RE: **Lot 21 Block 1 Volcano Cliffs Unit 22 SAD 228**
8005 Agua Fria Ct. NW
Grading and Drainage Plan
Engineers Stamp Date: 10/29/2020 (D10D003N14)
Pad Certification Date: 5/10/21

Based upon the information provided in your submittal received 5/14/2021, this plan cannot be approved for Grading Permit until the following comments are addressed.

SHEET TITLE:
**GRADING AND
 DRAINAGE PLAN**

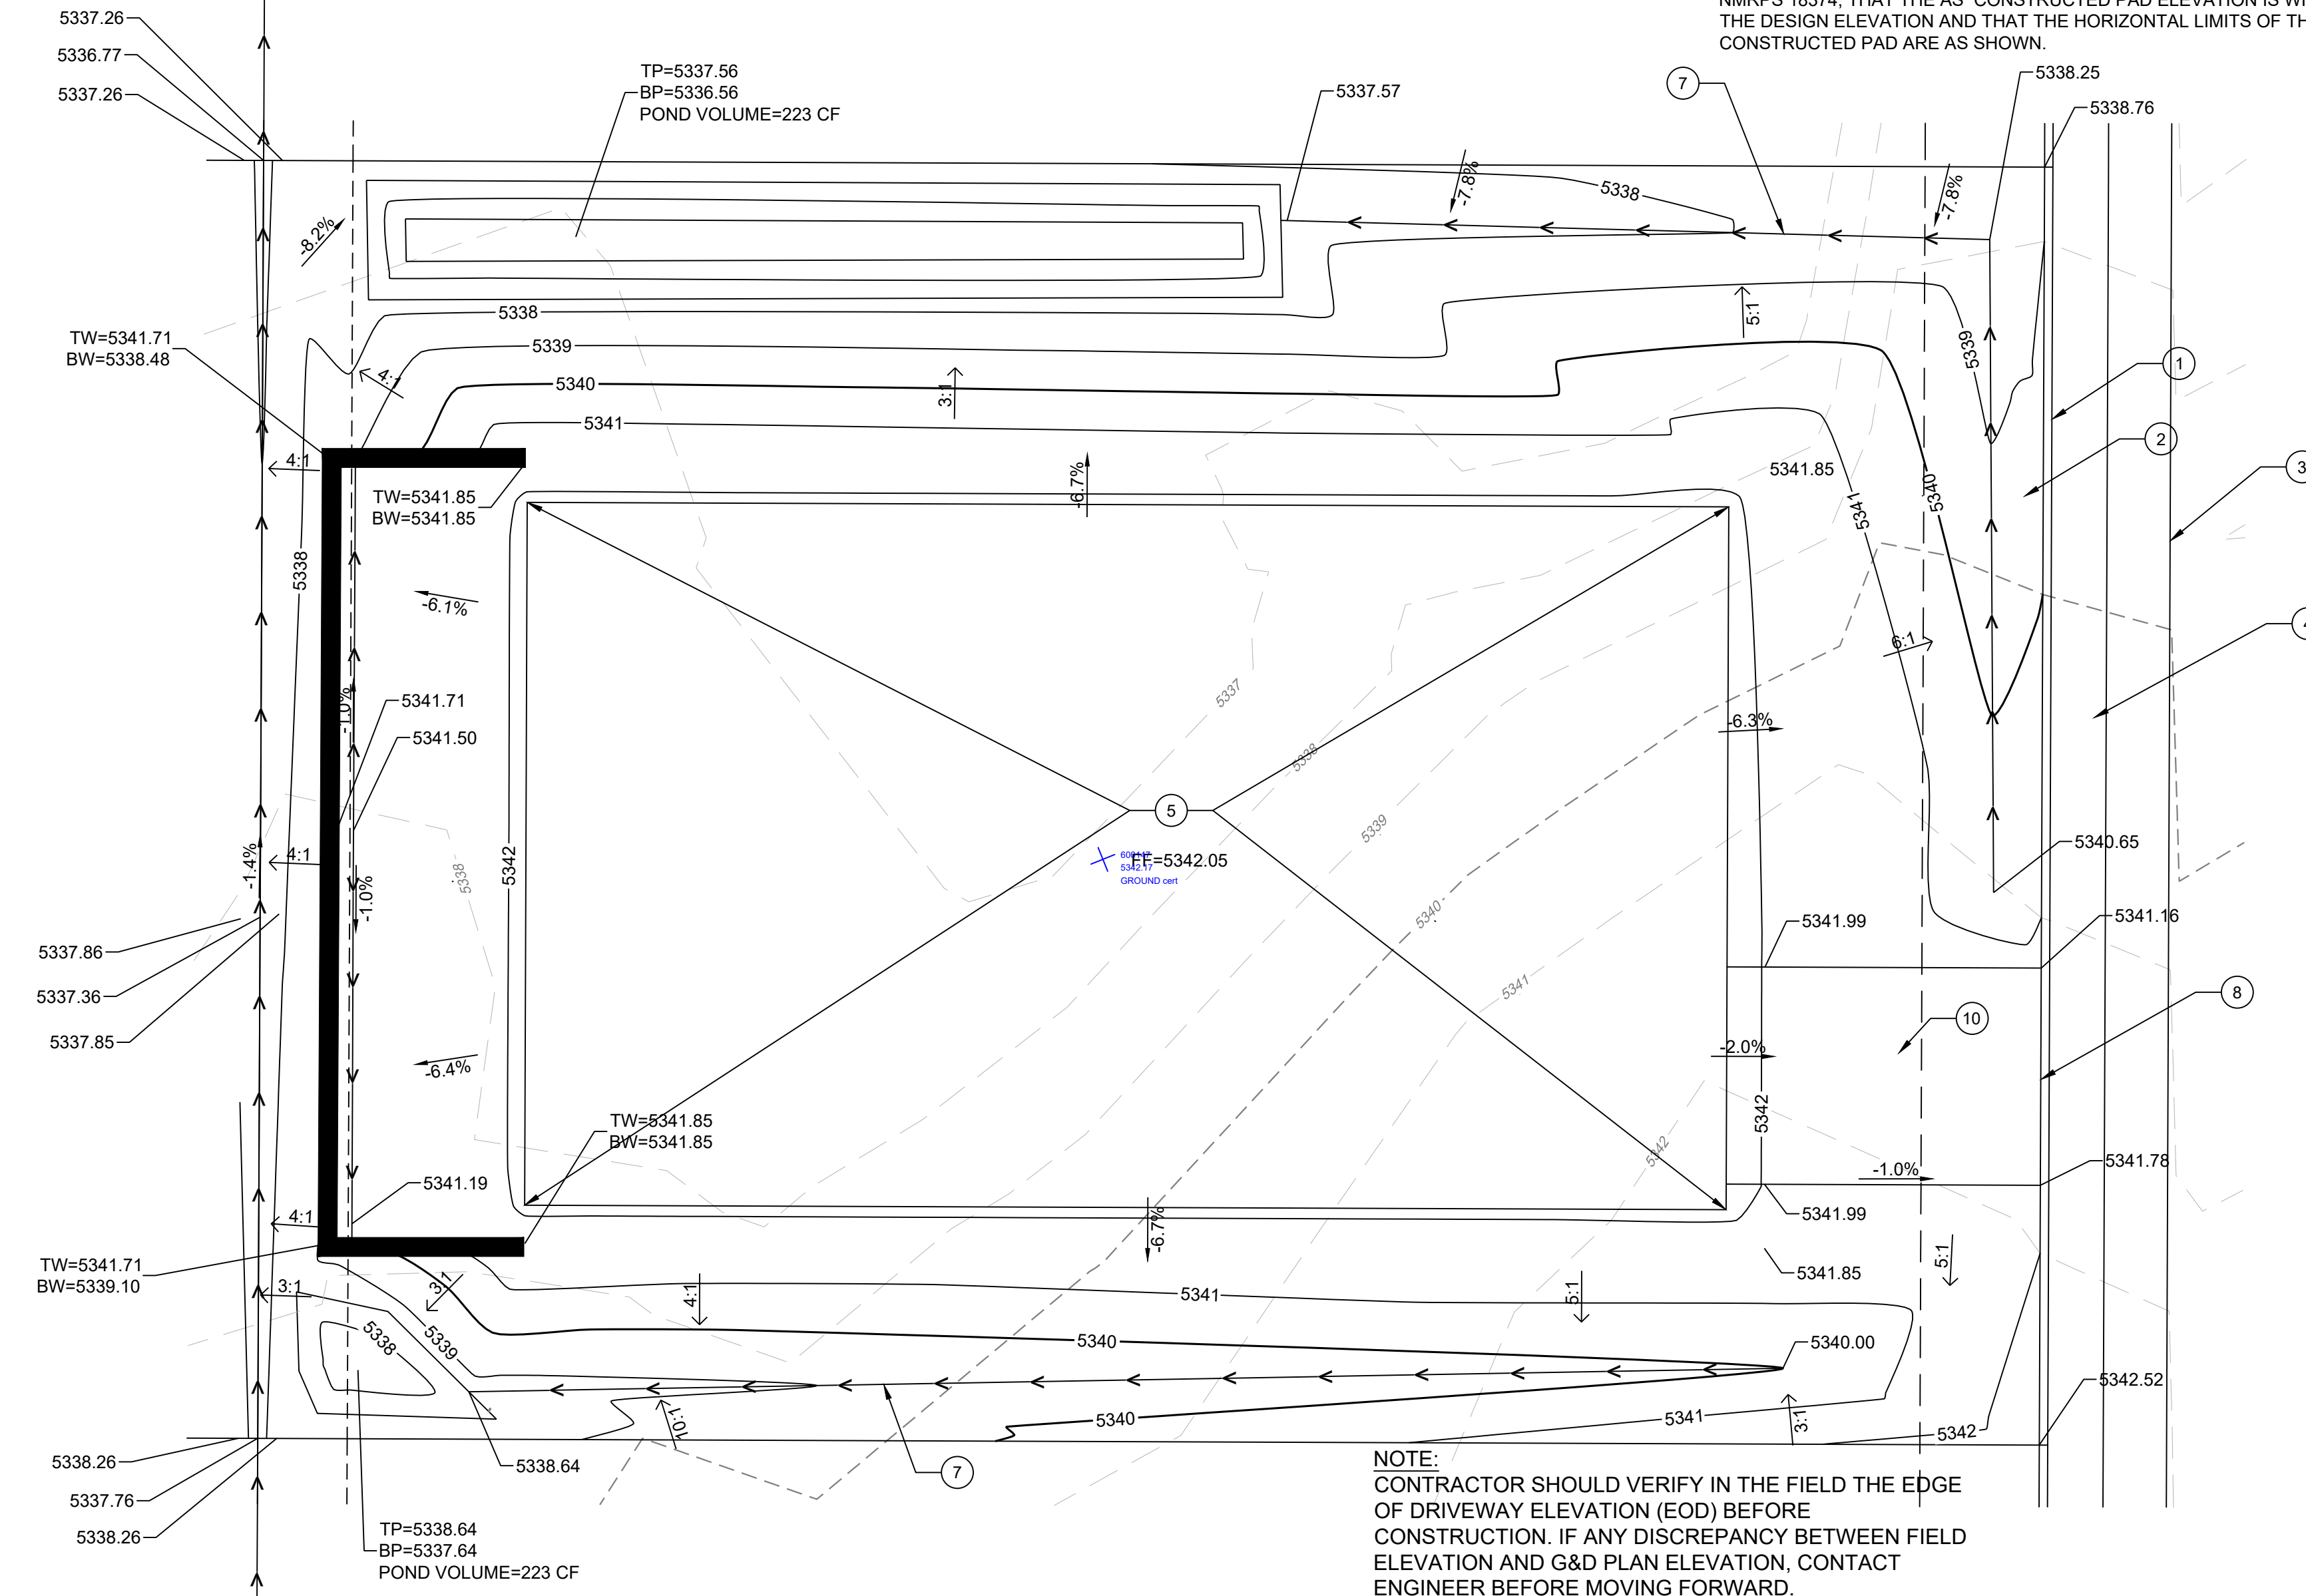
- Provide the approval letter or email given by Doug Hughes.
